LAND AT BIRD IN EYE FARM, UCKFIELD, EAST SUSSEX

TECHNICAL NOTE 3 – FURTHER TRANSPORT OBSERVATIONS

Figure 2.1: Visibility Splay to the West

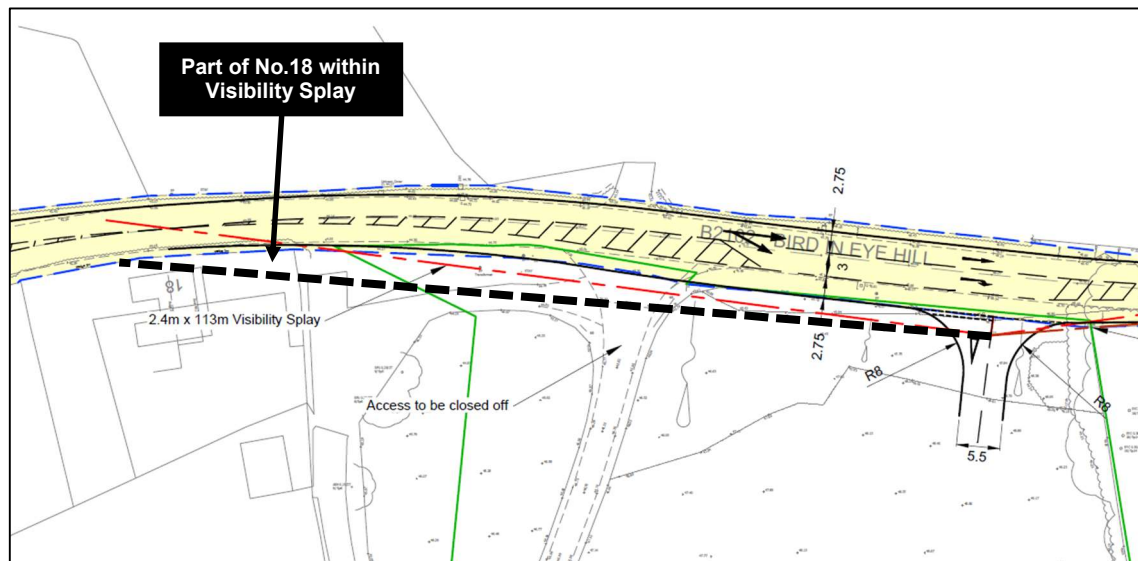
- 2.6 However, the visibility to the west has been measured to the centre of the eastbound lane (it is worth noting that this was previously measured to the centreline of the road) rather than the nearside kerb as is required unless overtaking movements are restricted.

- 2.8 The provision of a traffic island in this location will not prevent overtaking manoeuvres and so the visibility splay to the west should be measured to the nearside kerb. If this is the case, then the visibility splay will pass through the northeast corner of the garden of number 18 (Bird in Eye Hill) as shown overleaf in **Figure 2.1**.

- 2.11 Given that the introduction of a 30mph speed limit is by no means guaranteed, the level of visibility afforded at the site access junction must accord with actual speeds on the B2102 and be measured in the correct manner.
- 2.12 Clearly this is not the case at present so it is maintained that the site access will not be safe due to a lack of visibility to the west.
